LSC Responses to TIS Redline Comments

Grandview Reserve Phases 2 & 3 Preliminary Plan & PUD Traffic Impact Analysis (LSC #S234340) December 21, 2023 PUDSP-23-006 ¹

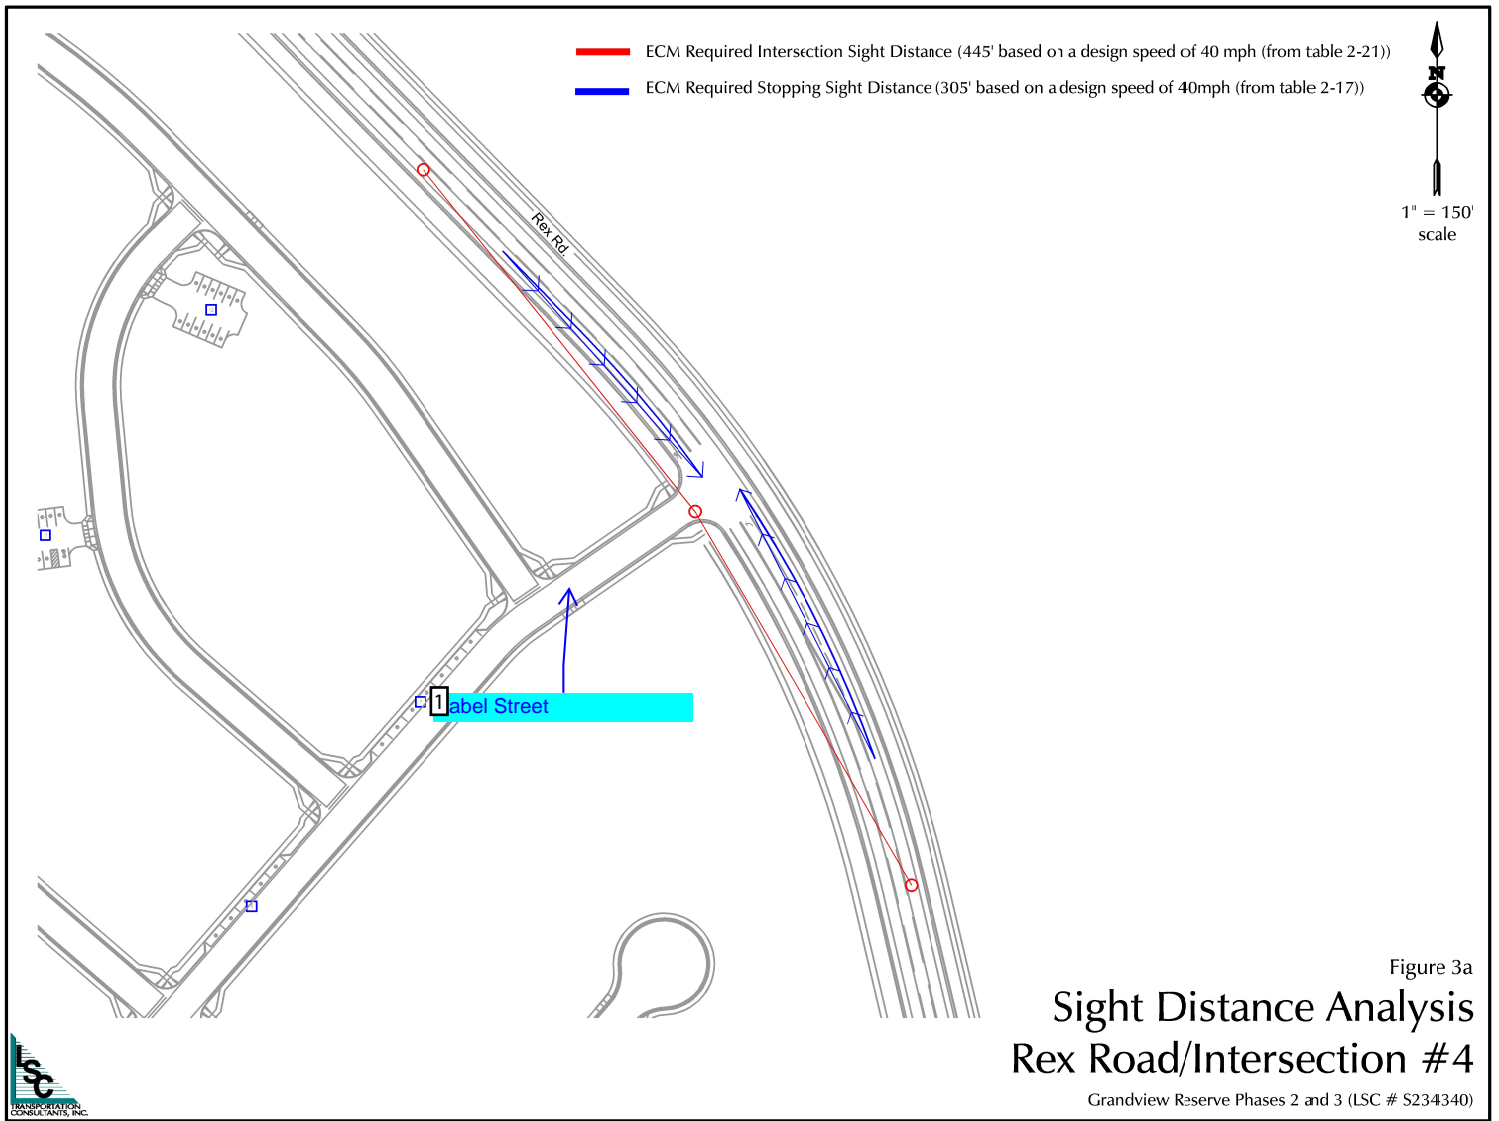
[Provide Street names](#)

Author: kdfer Subject: Sticky Note Date: 3/4/2024 10:42:15 AM
LSC Response: The figure has been revised as requested.

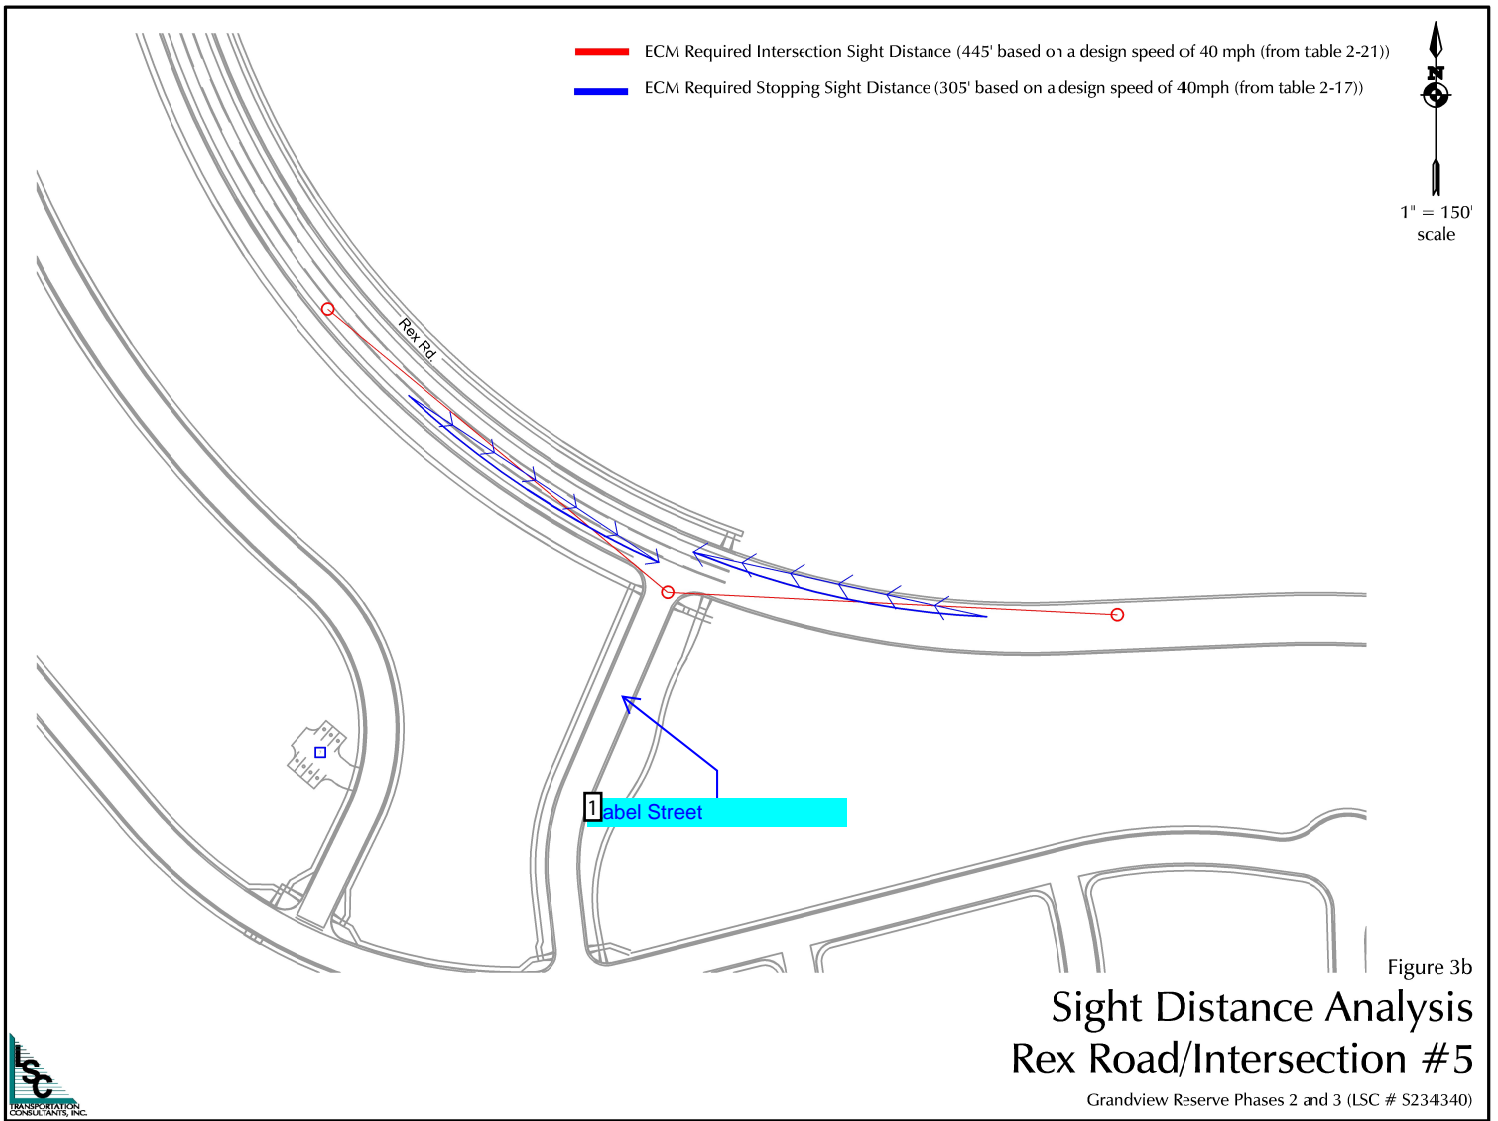
[Label Street](#)

Author: kdfer Subject: Sticky Note Date: 3/4/2024 10:42:23 AM
LSC Response: The figure has been revised as requested.

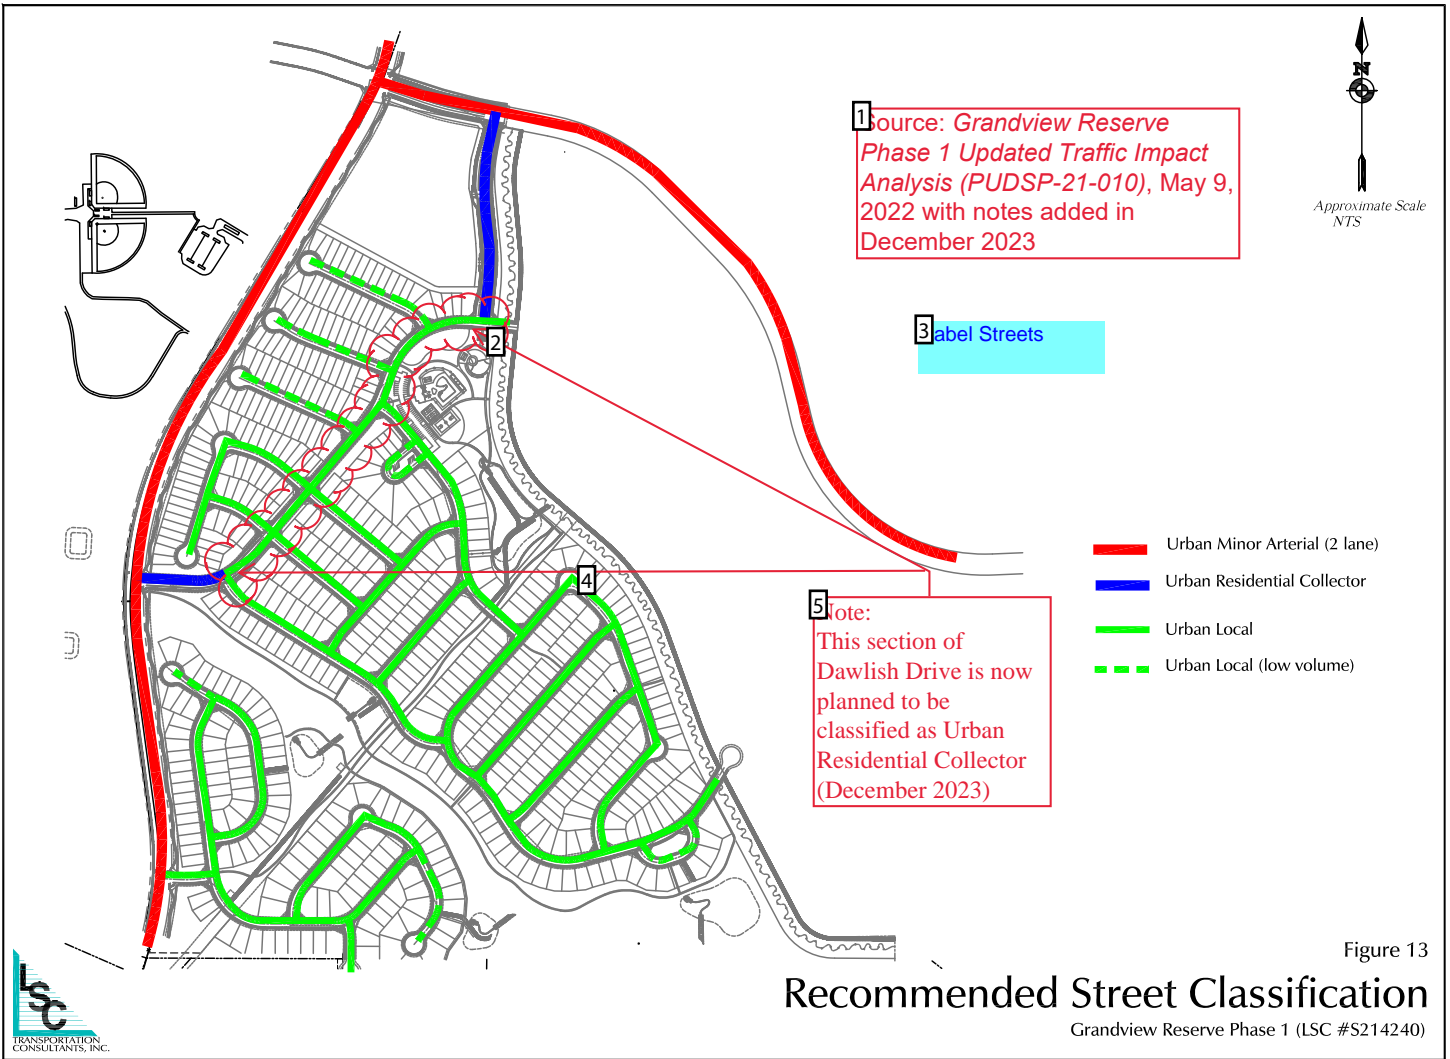
[Label Street](#)

Author: kdfer Subject: Sticky Note Date: 3/4/2024 10:42:39 AM
LSC Response: The figure has been revised as requested.
